LS POWER GRID CALIFORNIA's POWER SANTA CLARA VALLEY PROJECT

Volume III: Comments and Responses to Comments on the Draft Environmental Impact Report

A.24-04-017
State Clearinghouse No. 2024090200

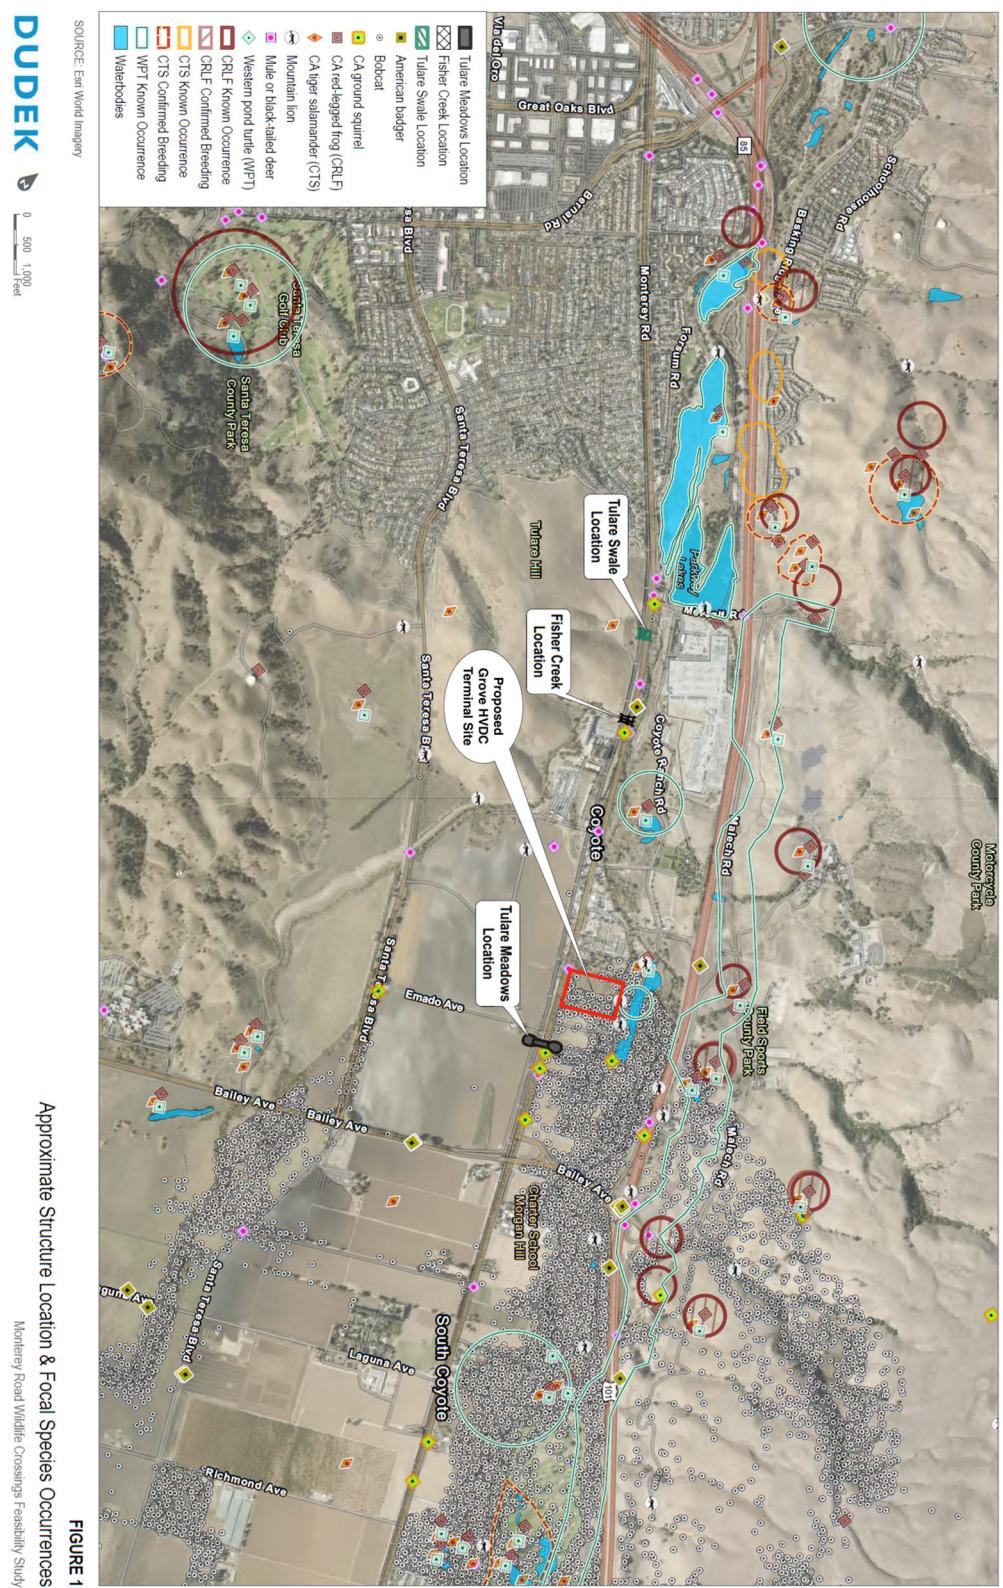
As explained in the Pathways for Wildlife Report, the Central Coast North population of mountain lions is present in both the Santa Cruz Mountains and the Diablo Range.¹⁴ They are also present in Coyote Valley, which serves to connect the wildlife populations in both mountain ranges.¹⁵ As shown in Figure 1 below, wildlife camera traps, roadkill documentation, and other observation data show that mountain lions traverse the area close to the proposed Grove Terminal site and utilize Fisher Creek and Coyote Creek as movement corridors. For example, a mountain lion was killed less than a mile away from the proposed Grove Terminal site near Highway 101 and Bailey Avenue.¹⁶ Also, in 2023, a juvenile mountain lion was killed on Santa Teresa Boulevard near the North Coyote Valley Conservation Area, which lies directly across Monterey Road from the proposed Grove Terminal site.¹⁷

Figure 1: Bobcat GPS collar data within the vicinity of the Grove terminal location.

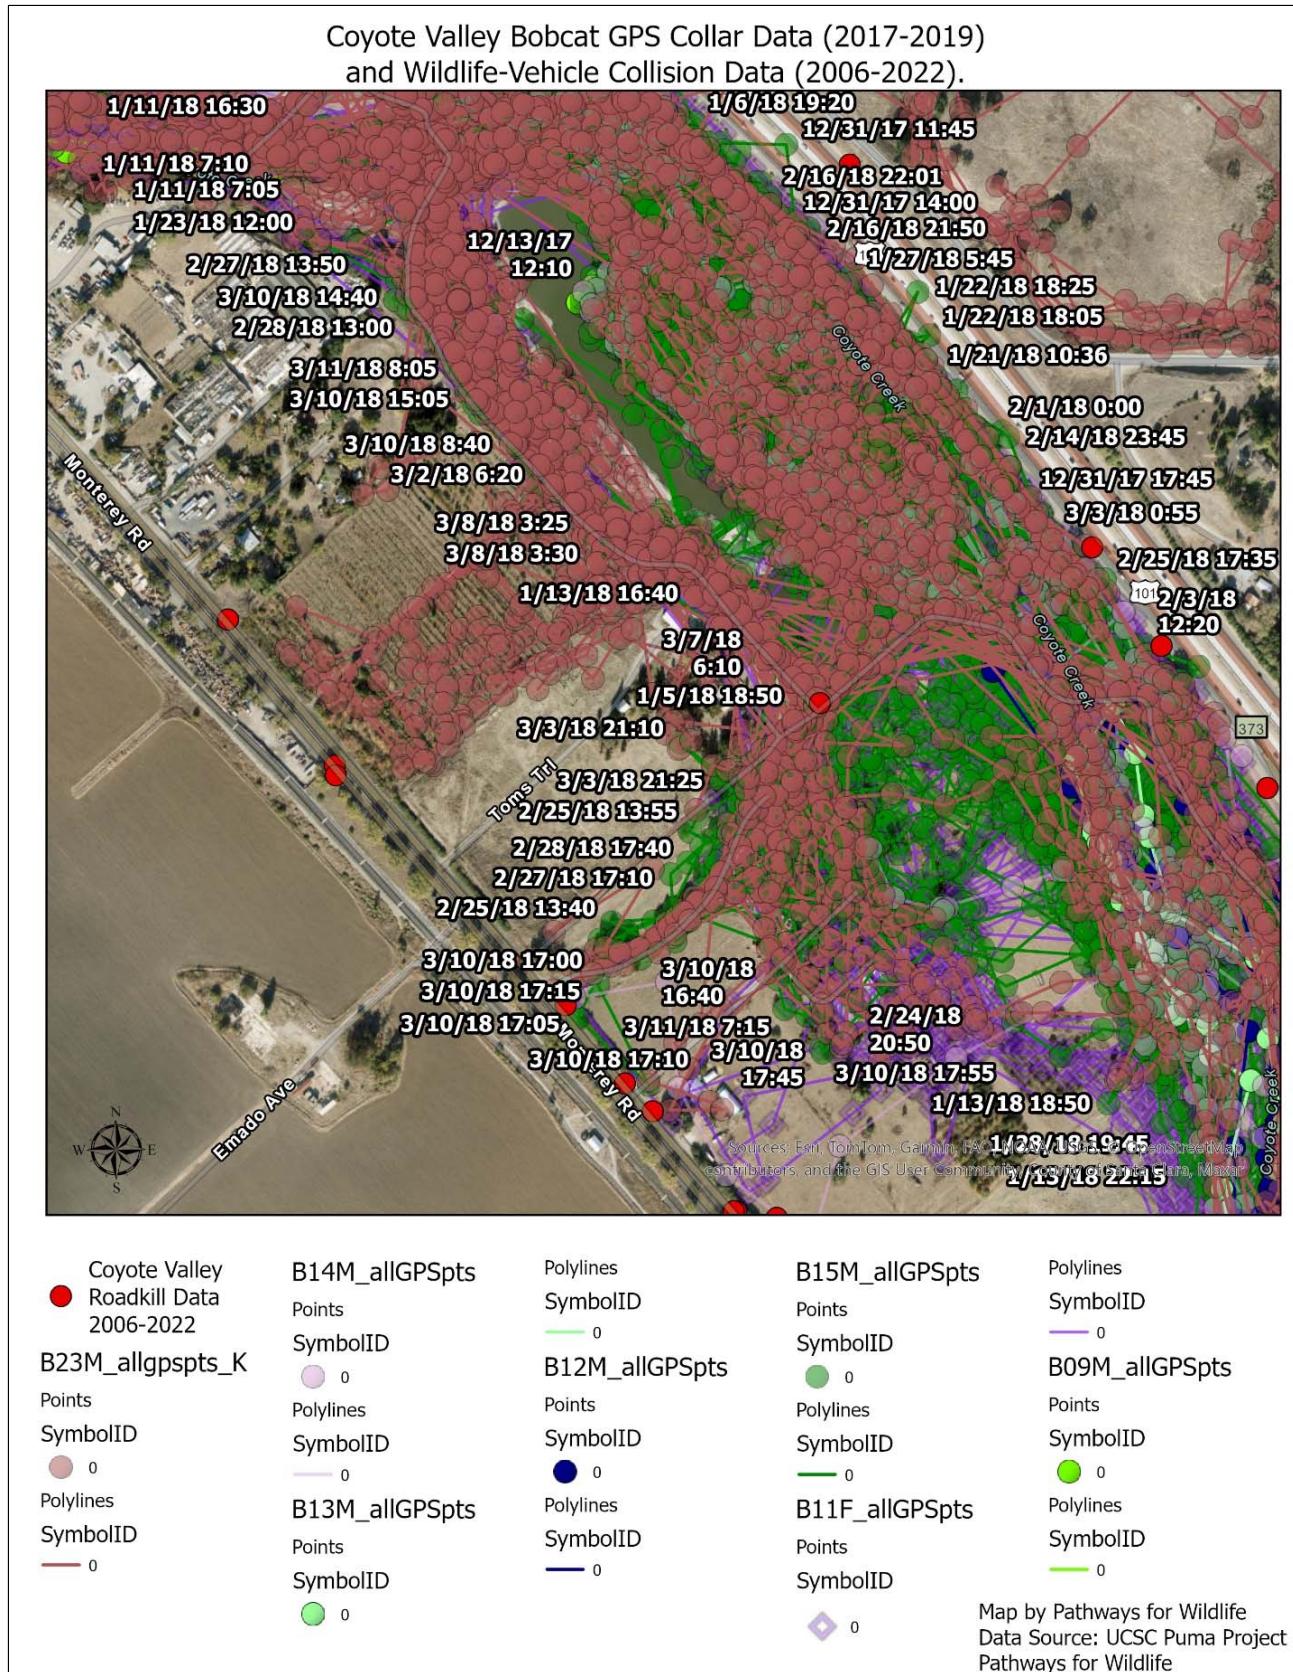
This data collection resulted in a comprehensive understanding of the regional corridor/linkage that wildlife are utilizing to travel across the valley floor. A critical part of this wildlife corridor/ linkage is Coyote Creek County Park and adjacent properties, such as the Grove Terminal location, which is currently an orchard. In Figure 1, we recorded 7 bobcats routinely traveling along Coyote Creek and adjacent habitats. **A collared bobcat,**

B23M, traveled within the proposed development area at the Grove Terminal location (Figure 1). Furthermore, multiple species of wildlife have also been recorded on Monterey Road at the Grove Terminal location (Figure 1).

This is why we claim that the statement: Project would not interfere substantially with the movement of any native resident or migratory fish or wildlife species or with established native resident or migratory wildlife corridors or impede the use of native wildlife nursery sites, is false. Wildlife have been documented utilizing the proposed development habitat at the Grove Terminal and routinely are traveling through Coyote Creek and adjacent habitats, which are critical components of the cross-valley wildlife corridor for multiple species.

Figure 3. Coyote Valley Wildlife Corridor in relation to mountain lion genetics and regional connectivity.

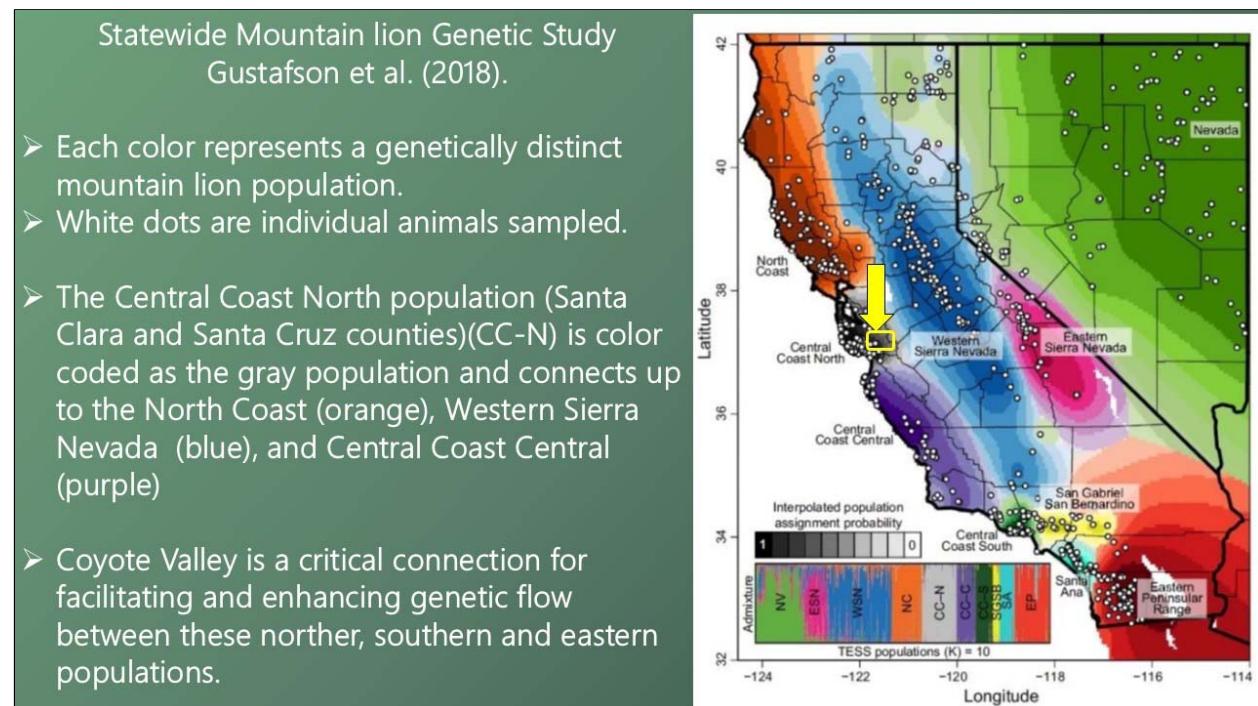
The Central Coast North population consists of Santa Clara and Santa Cruz counties (Figure 3). In 2018, a publication revealed that the Santa Cruz Mountain lion population has an effective population size of 16.6, while an effective population of 50 is needed to prevent inbreeding depression in the short term (Figure 4). The loss of wildlife corridor habitat at the Grove Terminal location will further constrain the Santa Cruz Mountains-Diablo Range linkage as an impact to regional wildlife connectivity.

Figure 5. Grove Terminal location within the proposed LS Power Grid California's Power development footprint.

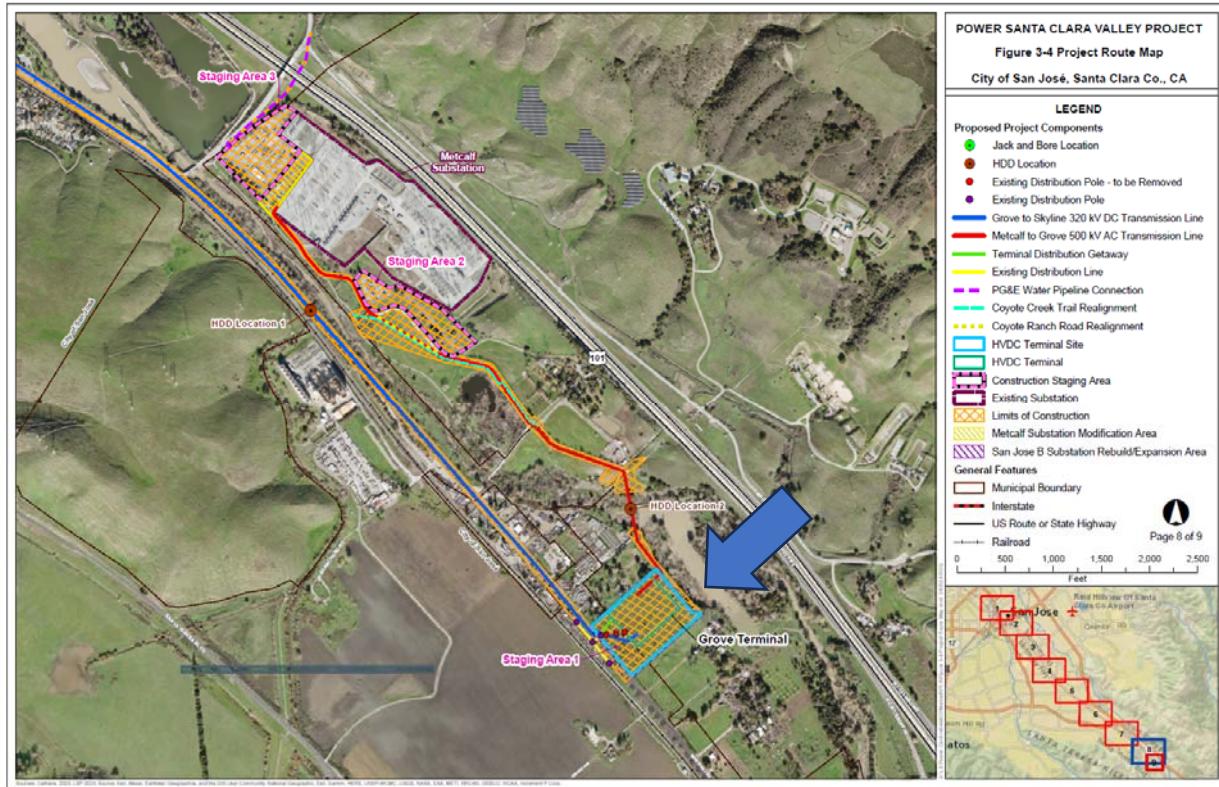
The location of the Grove Terminal is within the core of the Santa Cruz Mountains to the Diablo Linkage within Coyote Valley (Figure 5). At this location, there have been three records of mountain lions traveling adjacent to the Grove Terminal location (Figure 6). These data document mountain lion use of this section of the wildlife corridor.

Figure 6. Aggregated mountain lion occurrences in southern Santa Clara County, specific to the Coyote Valley region. Occurrences include camera trap, wildlife-vehicle collision, wildlife sign (scat/tracks), or visual observation from multiple studies and other verified sources.

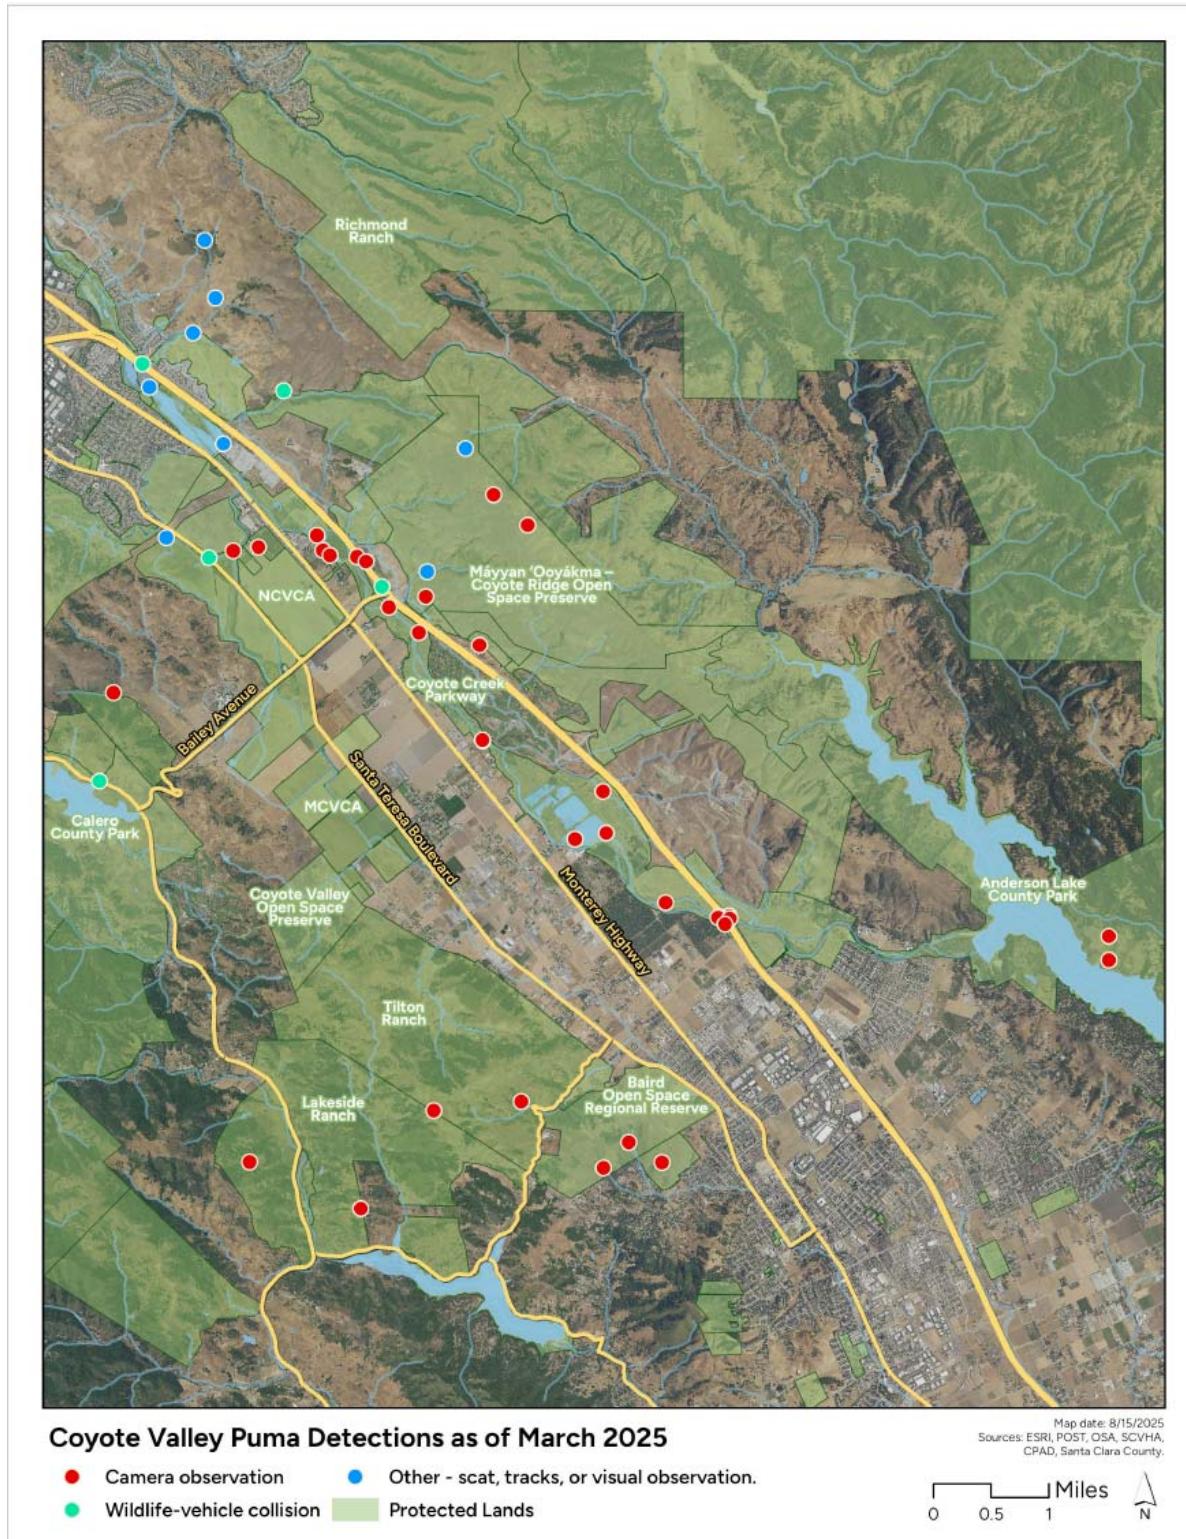
Question 4: Will there be mitigations included for reducing daytime construction noise levels that will not impact mountain lion movement through Coyote Creek, which is adjacent to the Grove terminal location, where mountain lions have been documented traveling along (Figure 6)?

Figure 8. CA Department of Fish & Game as a Terrestrial Wildlife Connectivity Barrier map for Coyote Valley.
<https://cdfw.maps.arcgis.com/apps/instant/sidebar/index.html?appid=c4017d600c06489aa115b6c8196975c0>

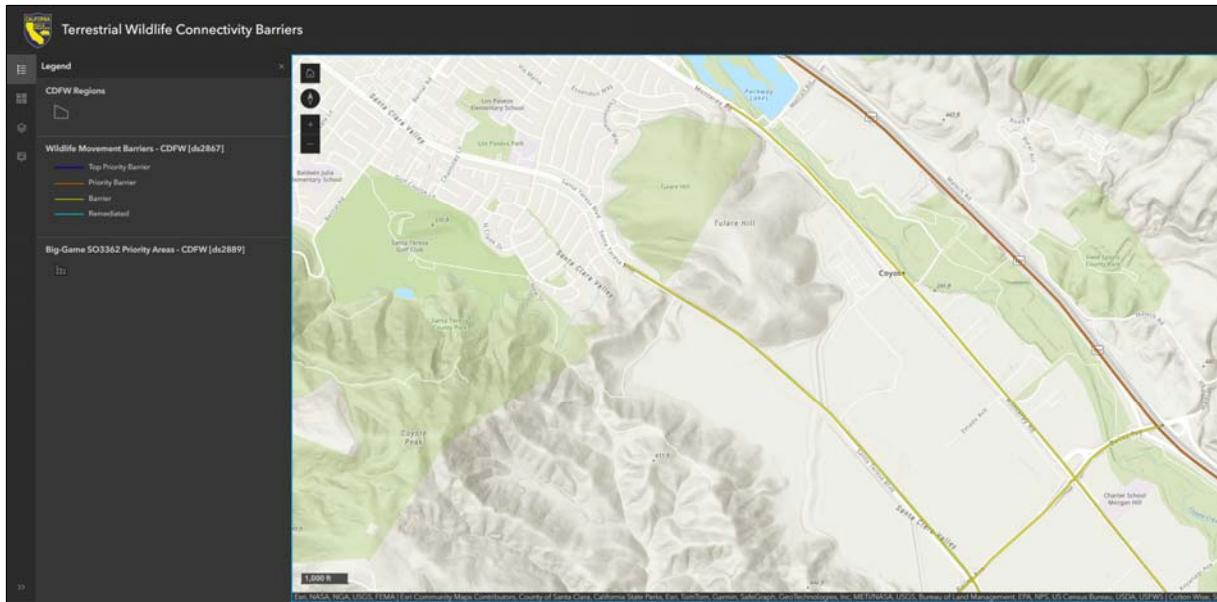
Comment 6: Furthermore, Monterey Road has been identified by the CA Department of Fish & Game as a Terrestrial Wildlife Connectivity Barrier (Figure 8). Caltrans has also identified US 101 in Coyote Valley as a wildlife connectivity barrier. The state awarded WCB funds to POST to conduct a planning project to determine the best locations for installing wildlife crossings along these two barriers and to plan, design, and environmentally clear one or more crossing structures.

The Grove Terminal location would increase traffic volumes along Monterey Road, which could result in increasing wildlife vehicle collisions on this stretch of Monterey Road. The Grove Terminal location could also deter wildlife from using a future wildlife crossing at Tulare Meadows and deter wildlife from moving along Coyote Creek to access the planned wildlife crossing at Fisher Creek.

Question 6: Will the final FEIR include an adequate analysis and mitigation for the increased traffic volume along Monterey Road that could result in increasing wildlife-vehicle collisions?
